Amendments to the Drawings:

Attached hereto are Annotated Sheets of the Application drawings, showing (in red) requested changes to FIGS. 2 and 3, and Replacement Sheets of the Application drawings, which replace the original sheet and includes the requested changes to FIGS. 2 and 3.

S/N 101625,273 (FILED JULY 23, 2003)
ANNOTATED SHEET SHOWING CHANGES

FIG. 2

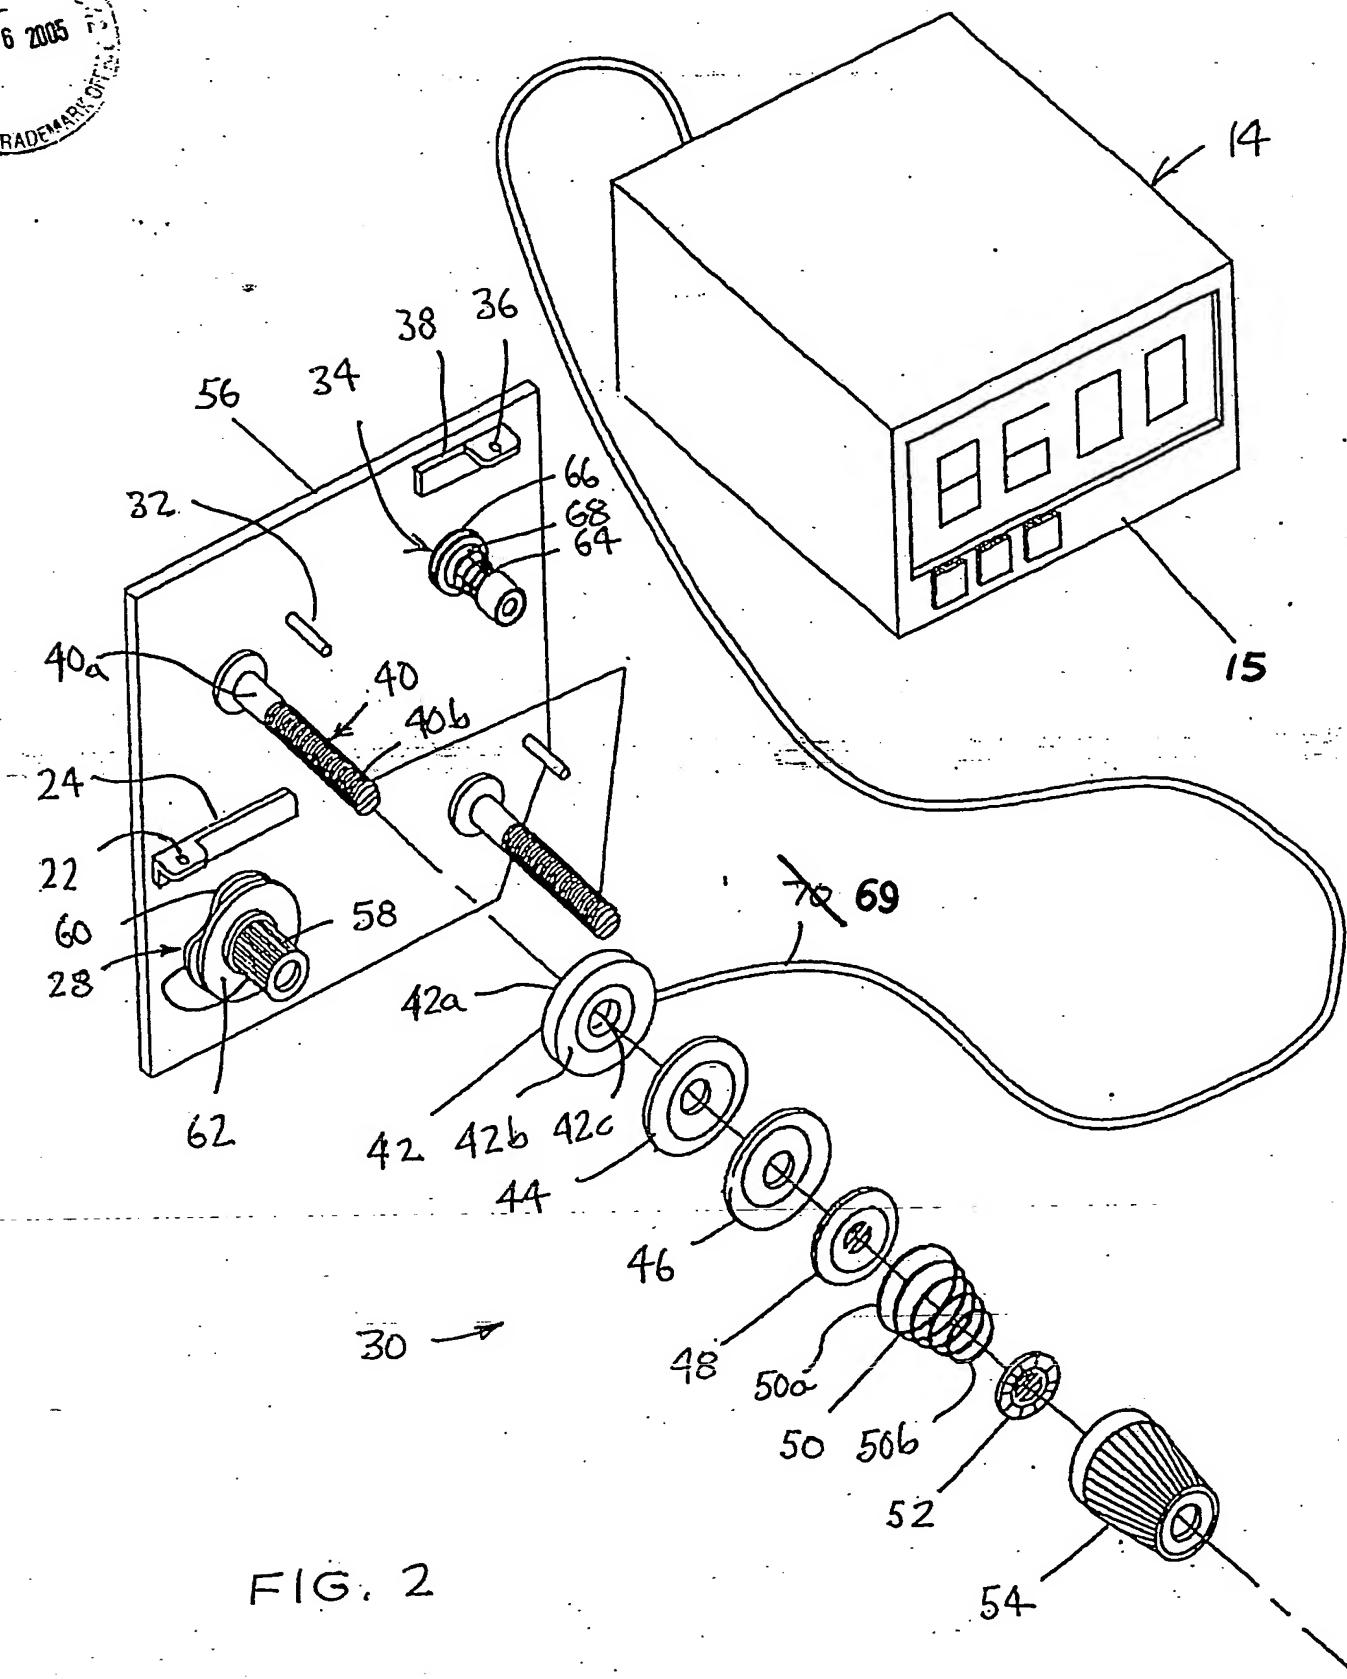
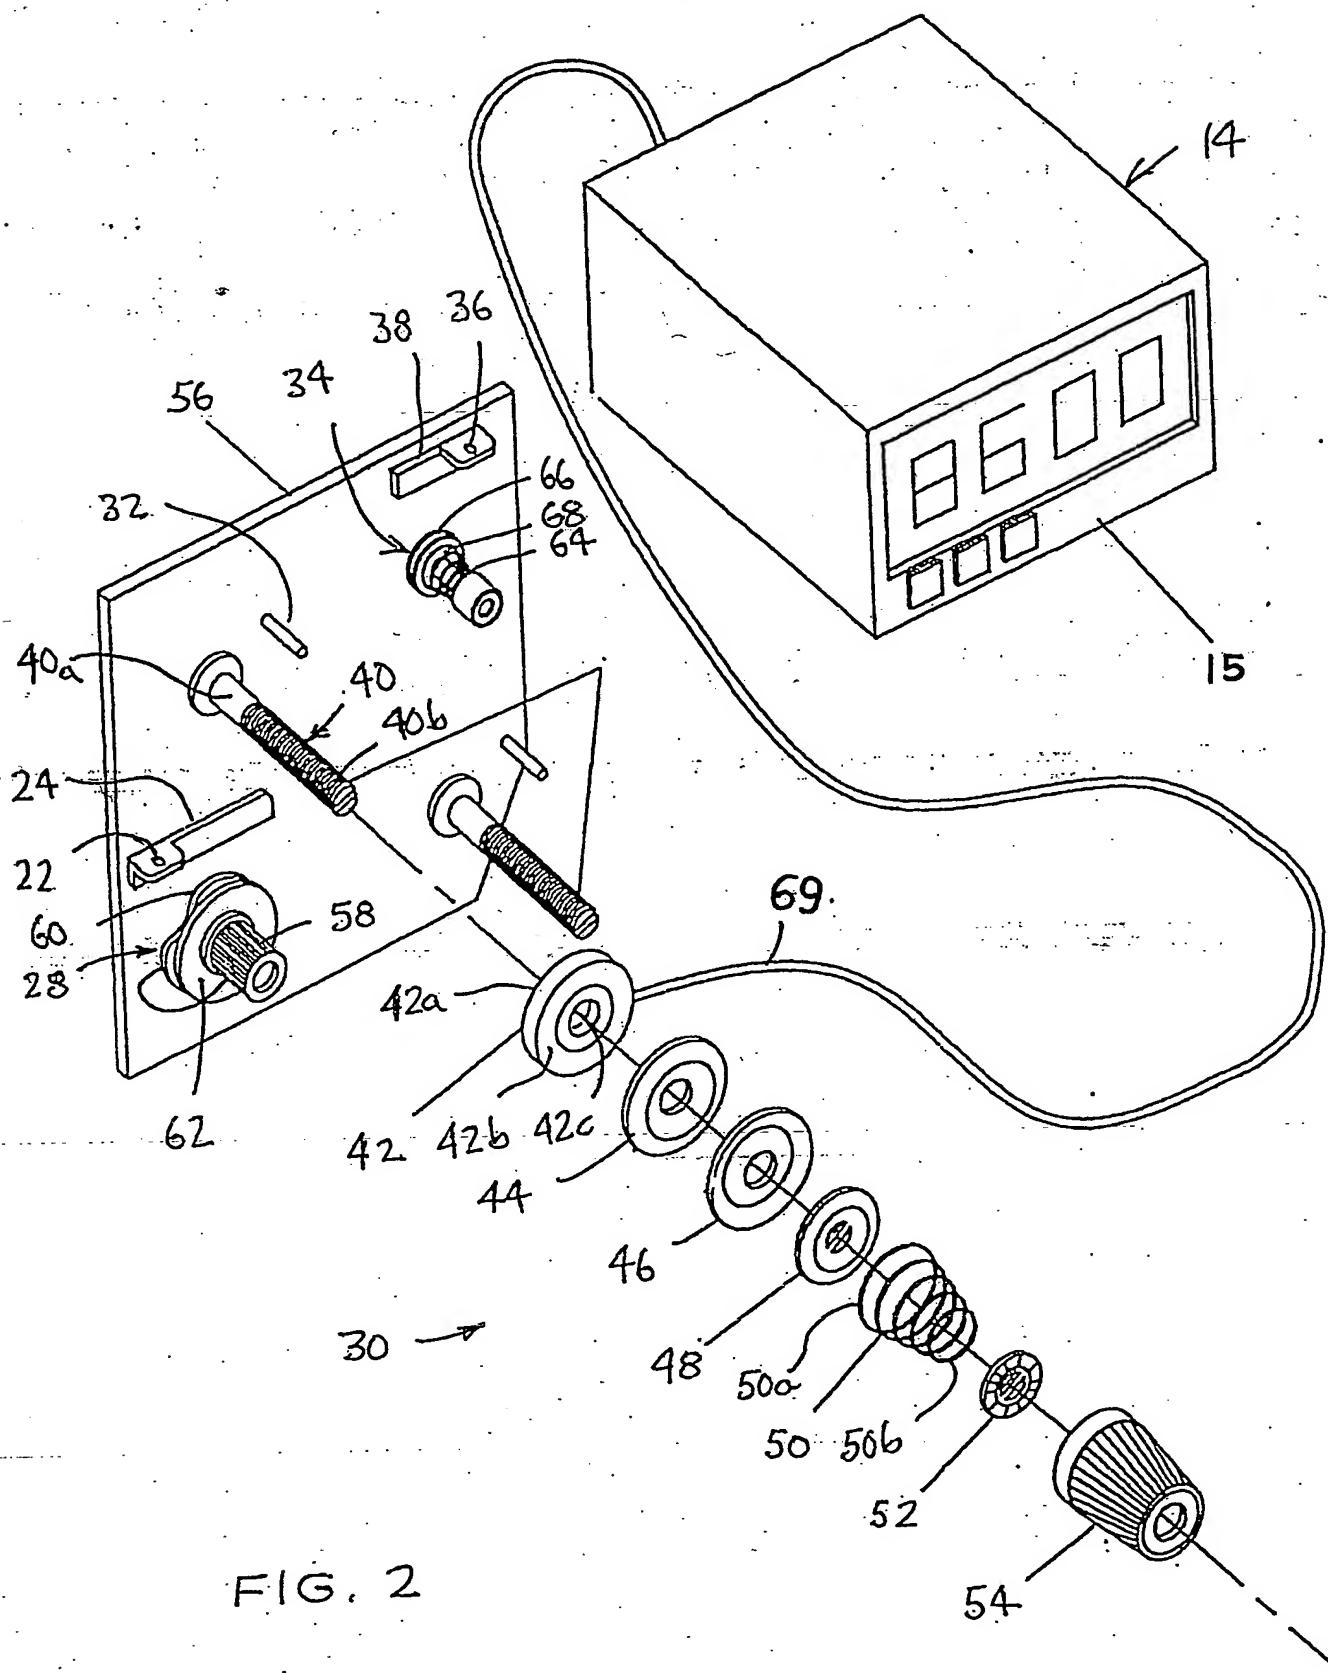
The changes to FIG. 2 comprise: (1) labeling the end of a lead line shown thereon, and pointing to a comparator, with the number – 15 – , and (2) changing the number of an electrical wire from “70” to .. 69 ..

The Examiner objected to the drawings, stating that the drawings must show every feature of the invention specified in the claims. In particular, the Examiner contended that a “comparator” recited in Claim 3 must be shown or the feature canceled from the Claim.

At the time of filing, Paragraph [00046] of the Specification discussed the comparator, and in FIG. 2 of the drawings. a lead line pointed to the comparator. Neither the term “comparator” nor the end of the lead line pointing thereto were labeled. By the action herein, Paragraph [00046] and FIG. 2 are amended by adding a number – 15 – after the word “comparator” and at the end of the lead line.

Paragraph [00039] of the Specification and FIGS. 2 and 3 of the drawings are amended to change the number of an electrical wire from “70” to .. 69 .. and to insert a period after the word “thereagainst” at the end of the paragraph. Paragraph [00046] of the Specification and FIG. 2 of the application are amended to label a comparator, described and shown therein at the time of filing, with the number .. 15 ..

FIG. 3

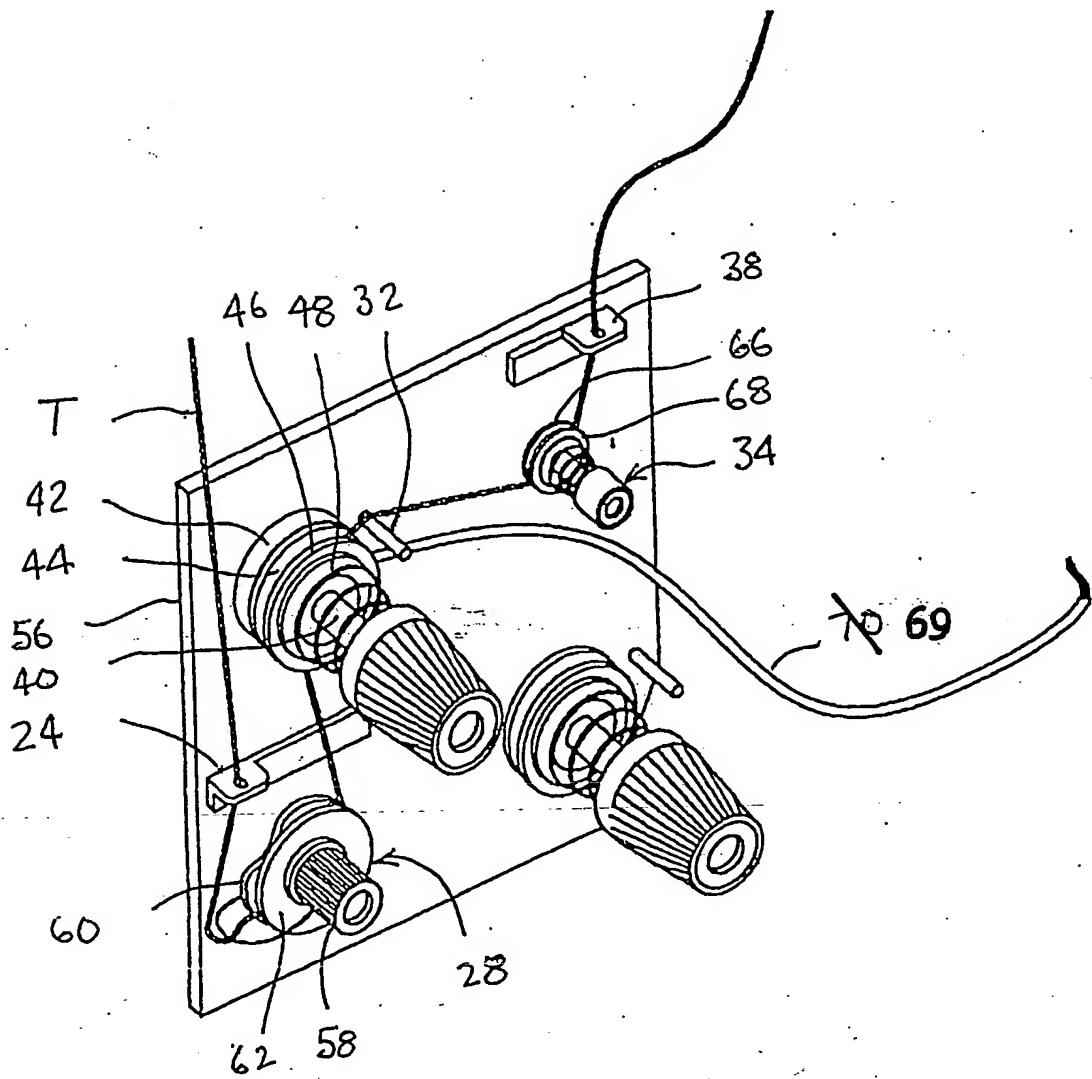
The change to FIG. 3 comprises changing the number of the electrical wire from “70” to .. 69 ..

Further, upon review of the Application, Applicant's Attorney noted that the number "70" was used in the application to identify an electrical wire (e.g., FIGS. 2 and 3) and also to identify a spacer or cylinder (e.g., FIG. 4 and Paragraphs [00048], [00049], and [00051]). The amendment herein to FIGS. 2 and 3 and Paragraph [00039], wherein the wire is renumbered as -- 69 --, is believed to obviate any indefiniteness.
